## DEPARTMENT OF THE ARMY

SUBJECT: FY18 Joint Routine Inspection of Completed Works, Flood Risk Management Project, Genesee River and Dyke Creek, Wellsville, New York (09/24/18)

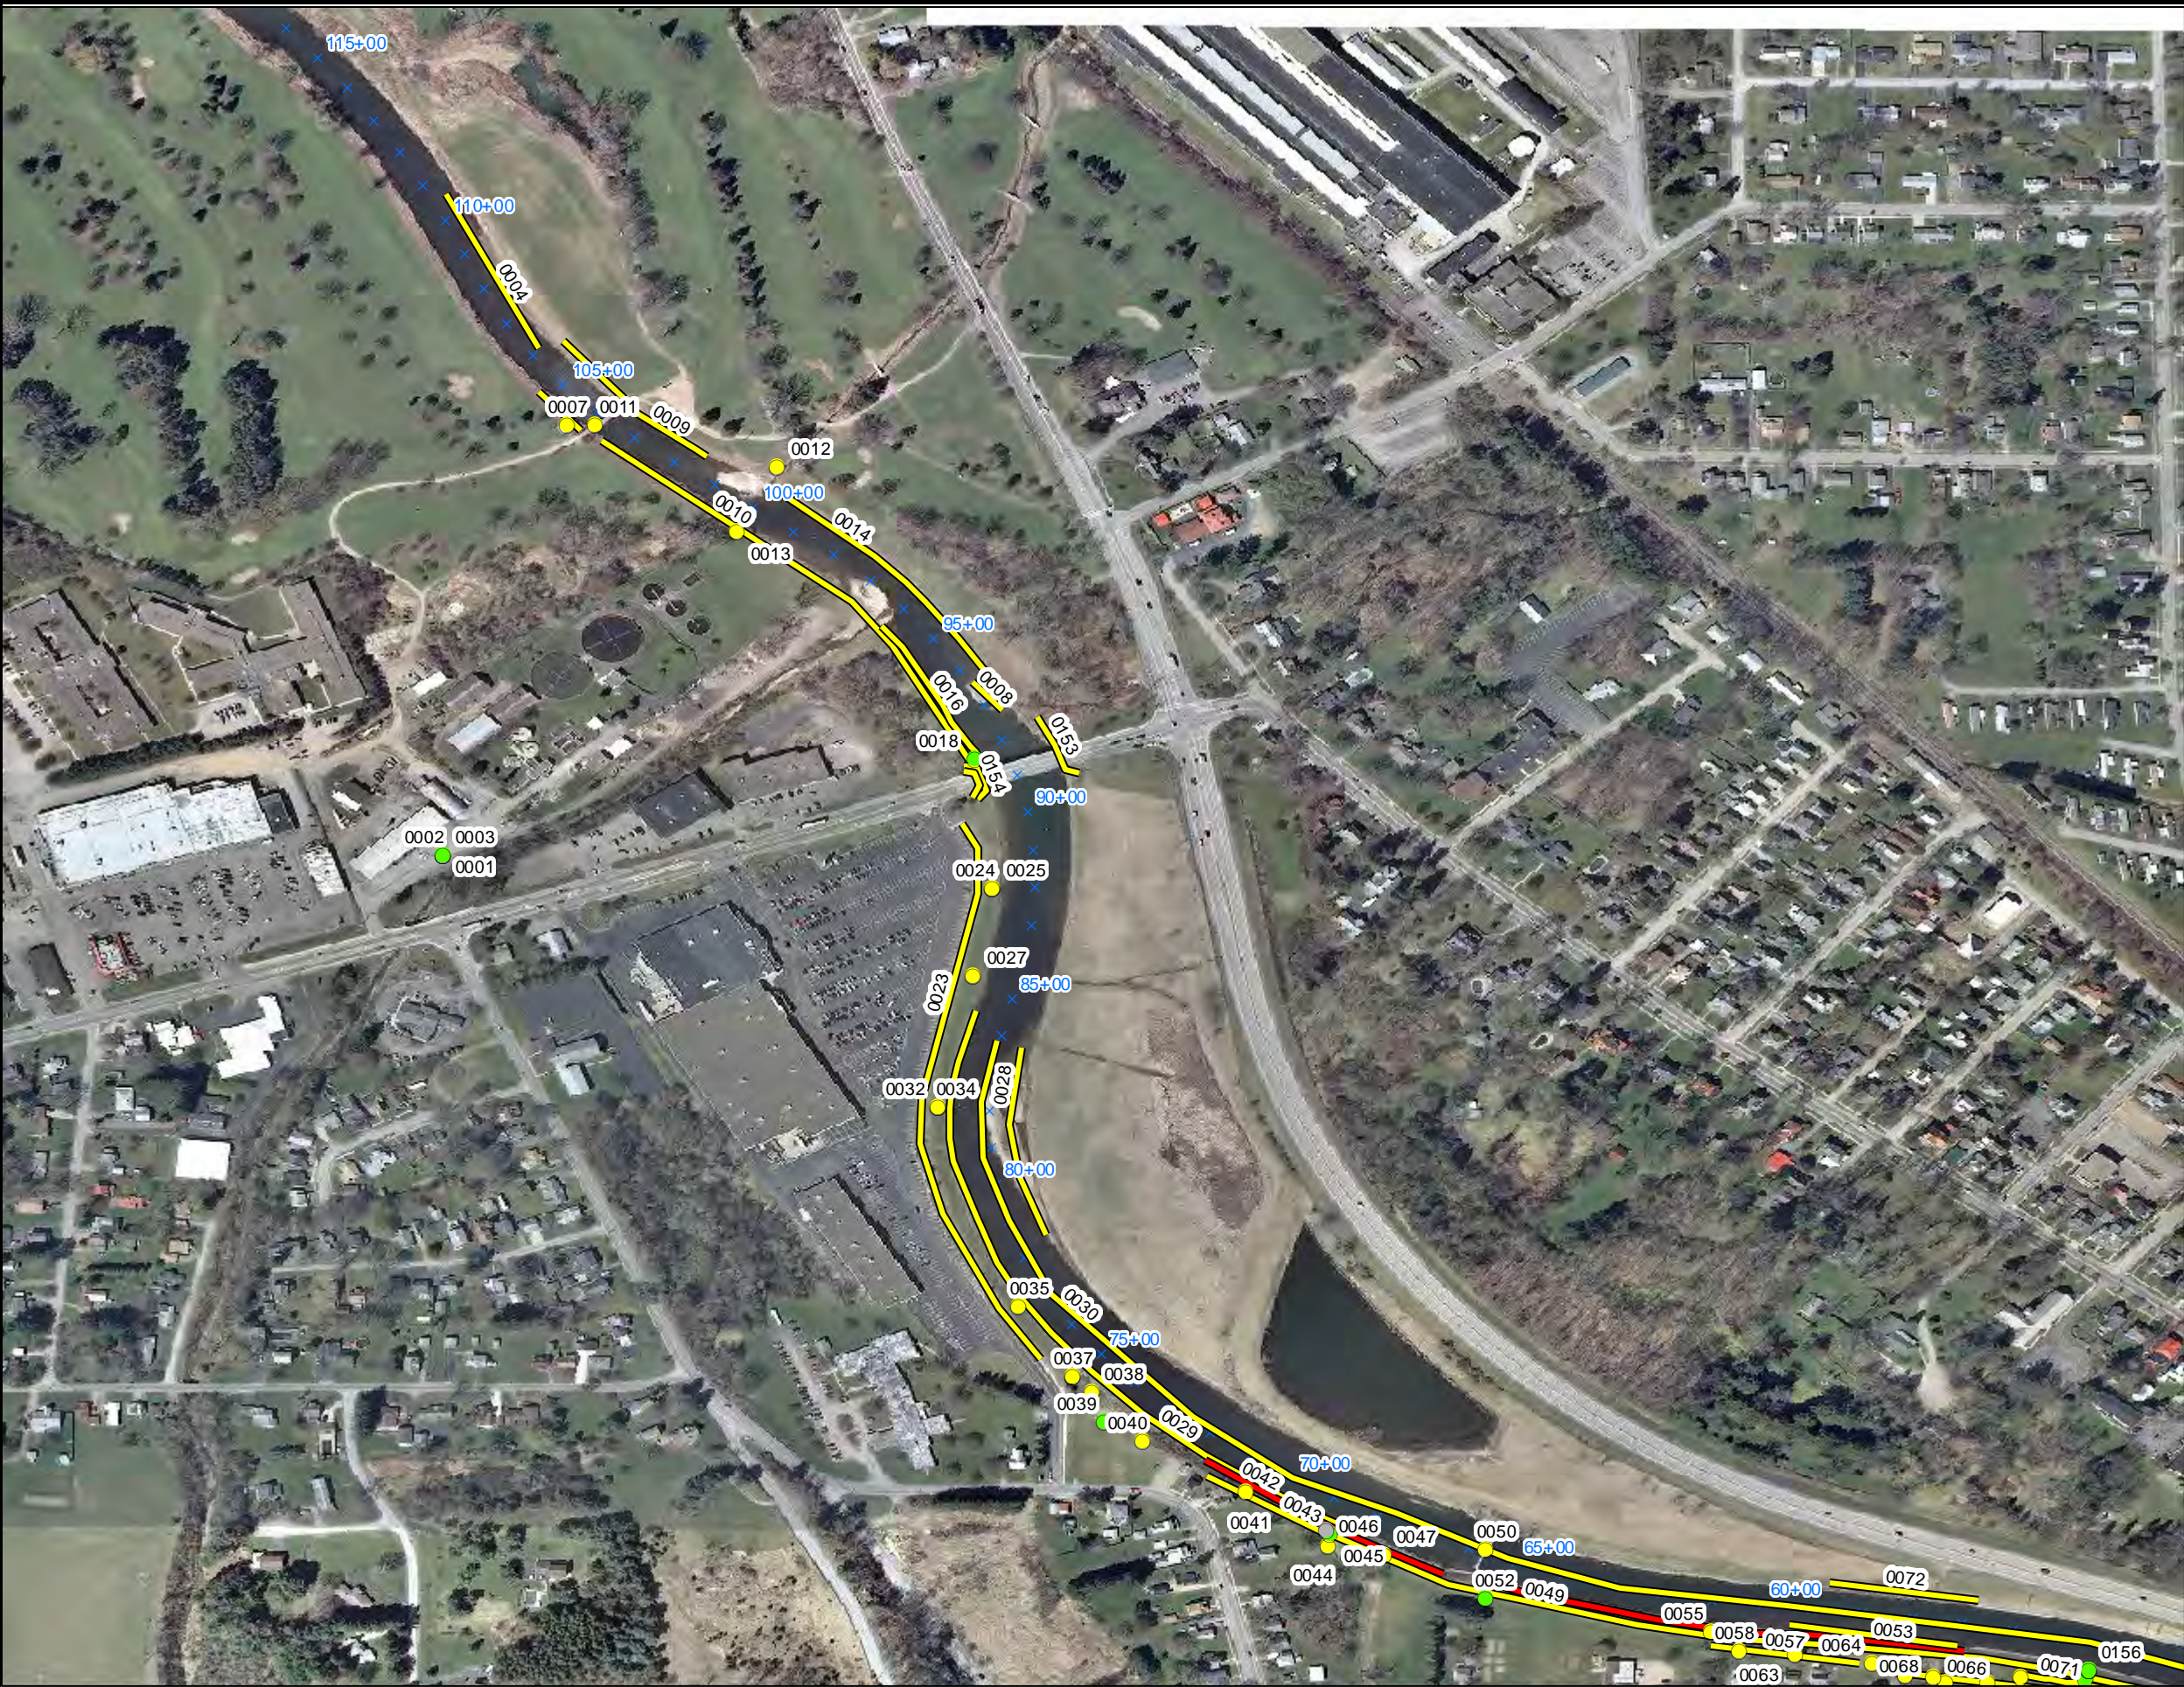
**Inspect ID:** N21L\_2018\_r\_0165 **Title:** USACE\_CELRB\_N21L\_2018\_r\_0165\_1.jpg  
**Rated Item:** 10. Riprap Revetments & Banks **Caption:** Rating: Minimally Acceptable;  
Remarks: Trees and vegetation in riprap on left bank around both sides of Island Park  
Pedestrian Walkway Bridge; Action: Remove trees and vegetation from riprap.;  
Station\_1: 17+00; Station\_2: 16+00
